MUNICIPALITY: CITY OF JEFFERSON, GA.  
PROJECT: JEFFERSON 1-85 IMDG WRF  
ENGINEER: CIVIL ENGINEERING CONSULTANTS, INC.  
CONTRACTOR: \*\*\*  
LOCATION: JEFFERSON, GA.  
DATE: 02-10-2023  
DRAWN BY: GCS

APPROVED BY  
LAKESHORE ENGINEERING  
ISSUED FOR FIELD USE  
2.21.23

PROJECT NAME				JEFFERSON, GA			
PROJECT DESCRIPTION				AEROBIC DIGESTER - LAYOUT			
ED I FLEXAIR® AERATION-MIXING SYSTEM							
FOR:	BY:	DATE:	SCALE:	FOR:	BY:	DATE:	SCALE:
TEM	KPR	7/7/2022	1/8"=1'-0"				
Environmental Dynamics International		wastewater.com		P: +1 573 474 9456 F: +1 573 474 6988		5601 Paris Road Columbia, MO 65202	
PROJECT NUMBER		SHEET NUMBER		DWG NUMBER			
38117		1 OF 2		167053

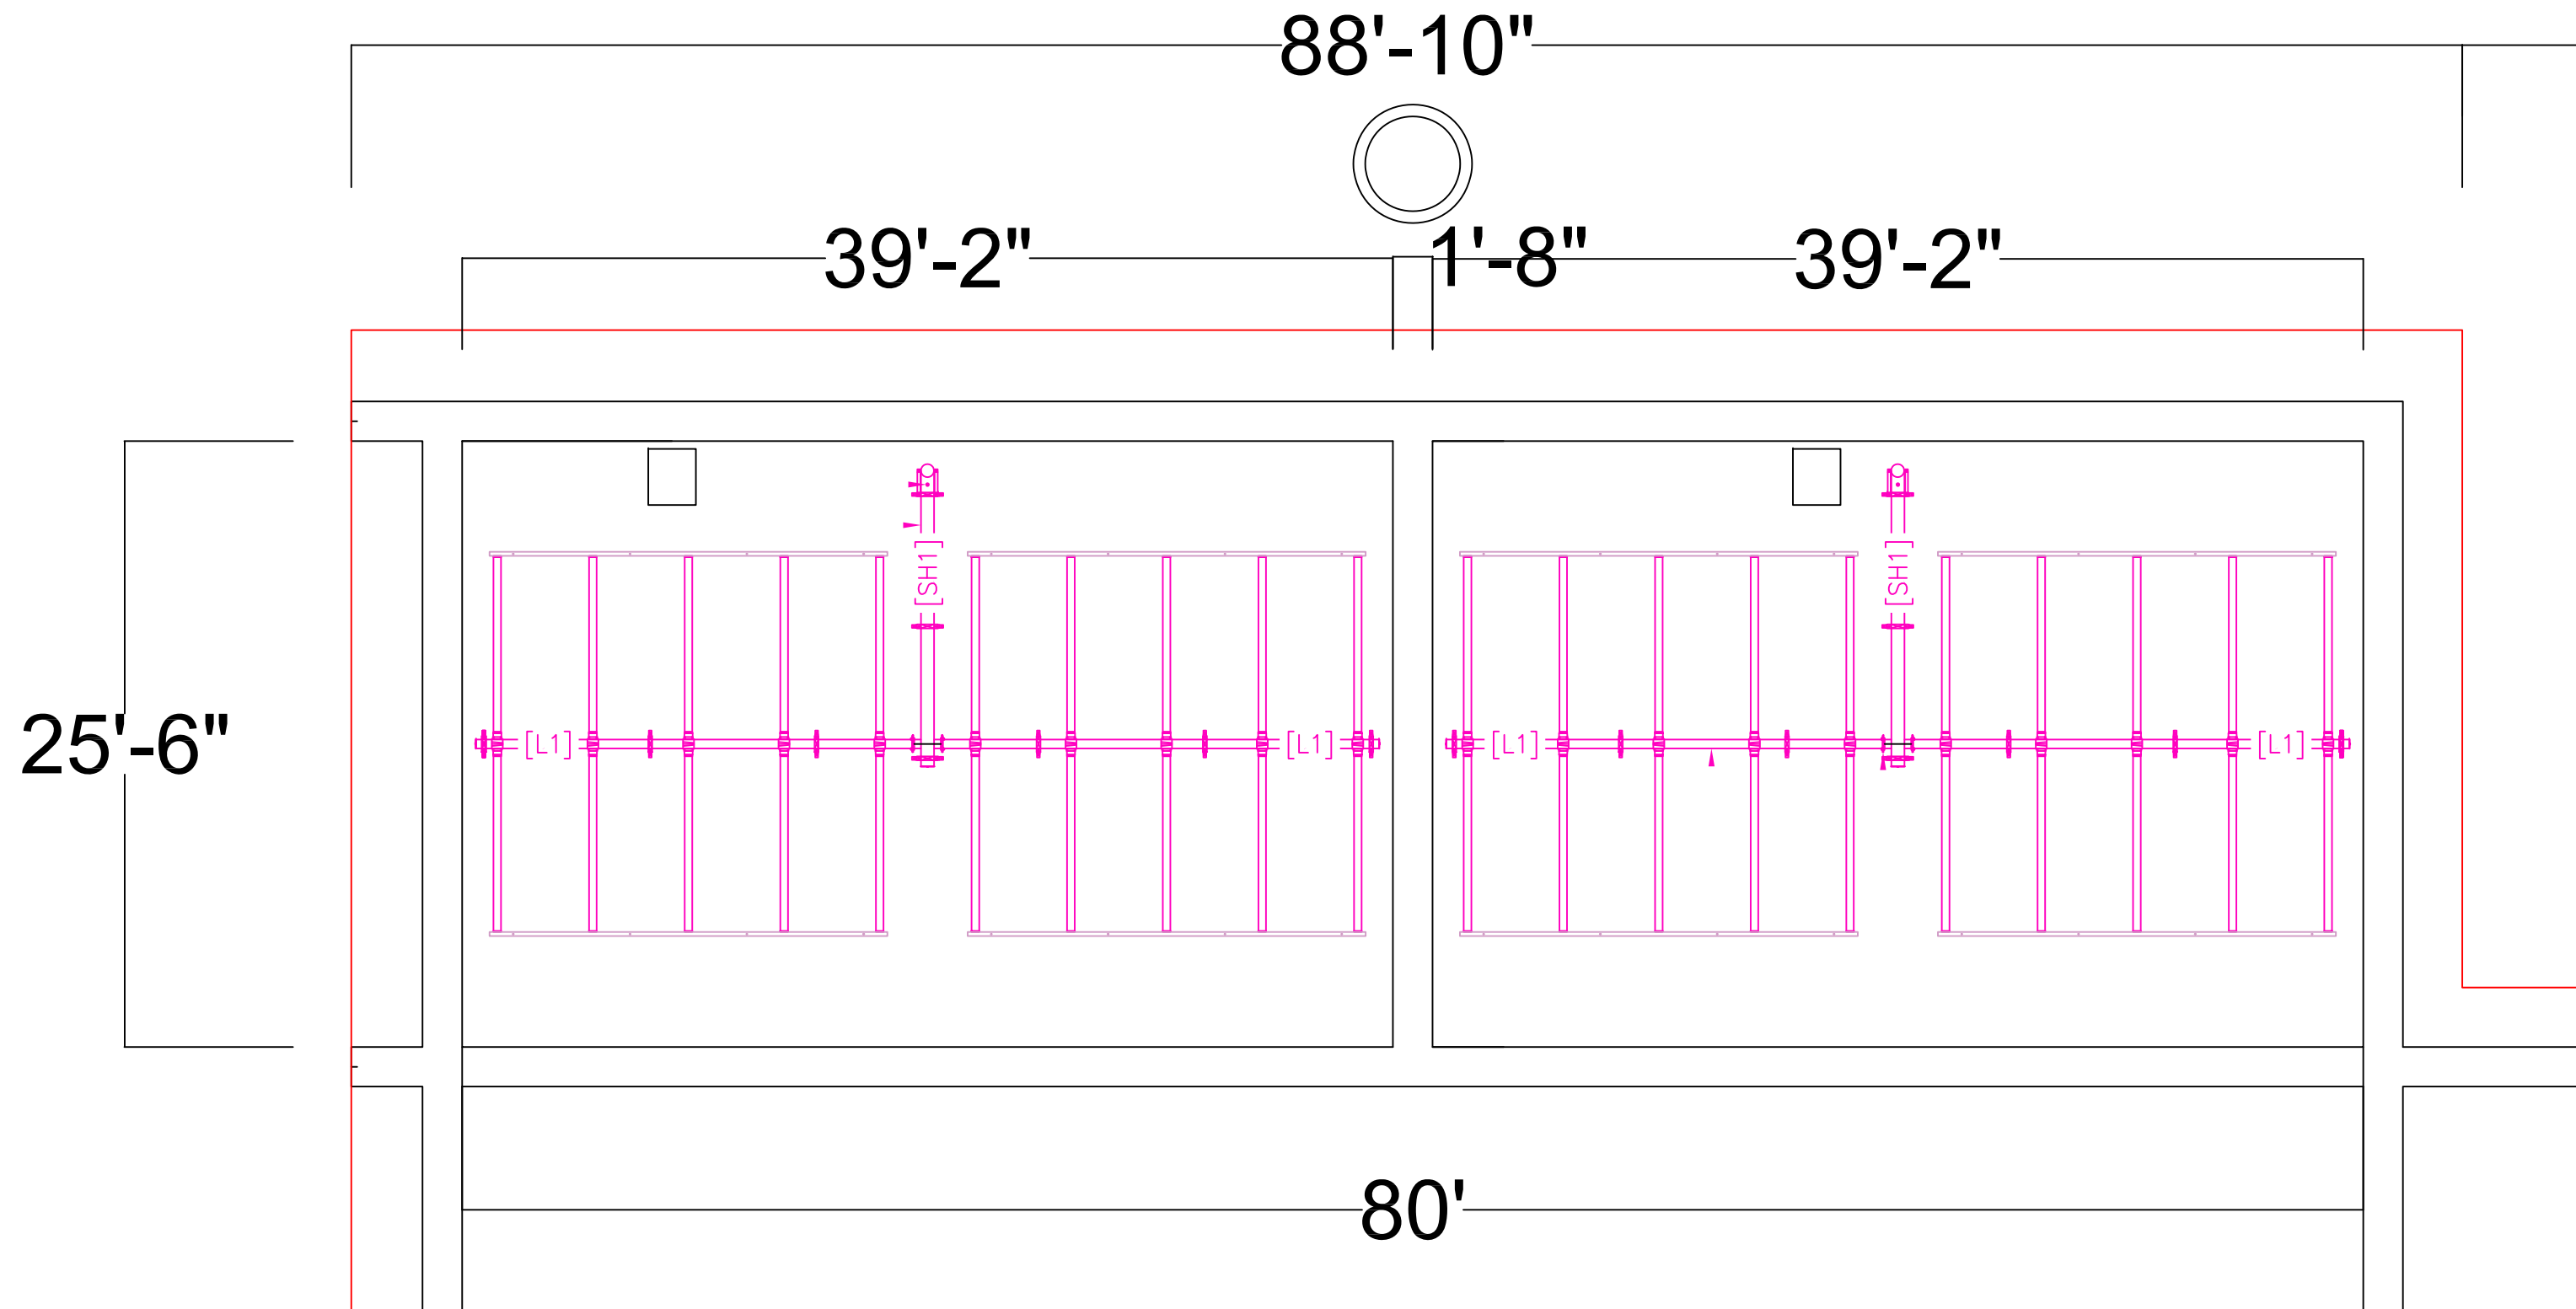
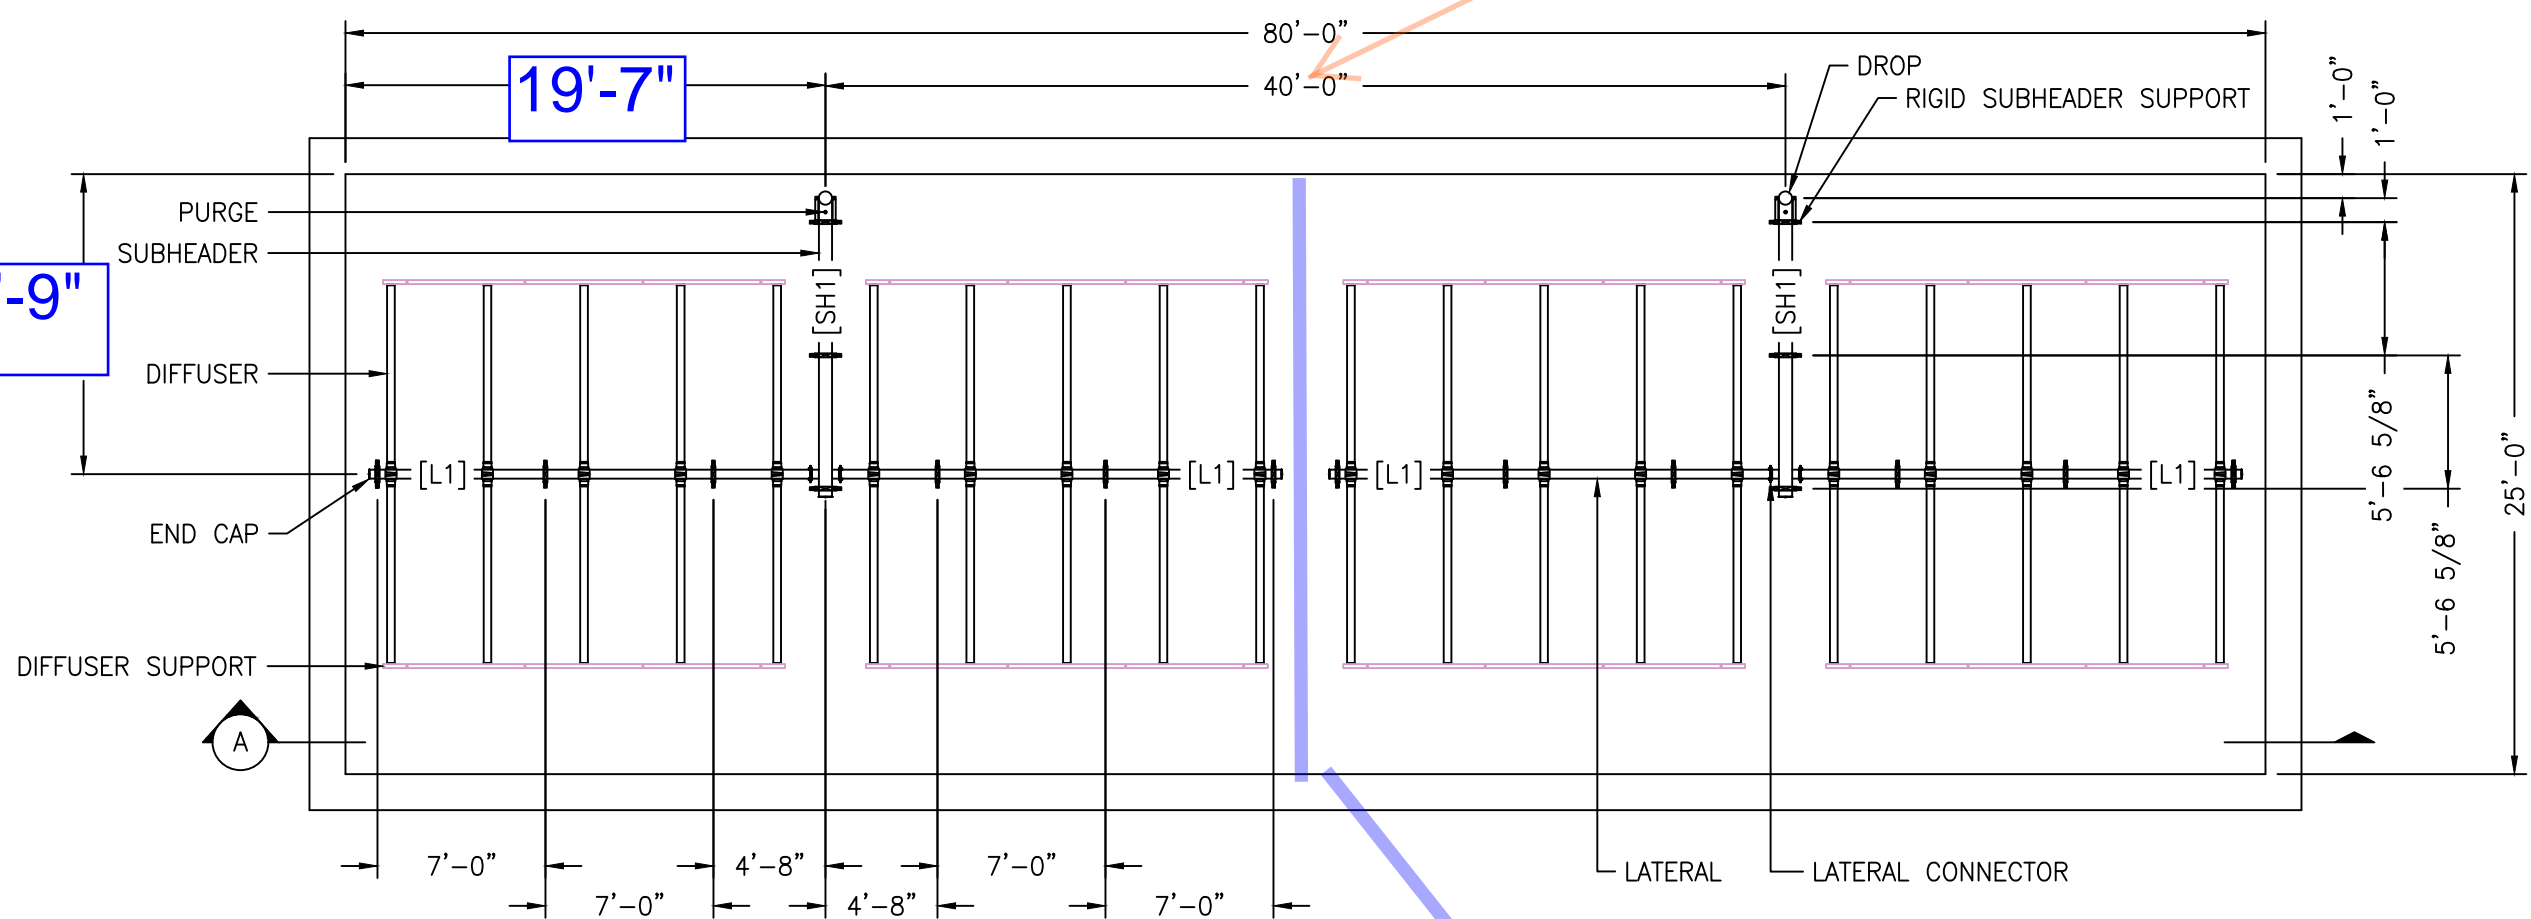
Contractor note modified  
diffuser layout
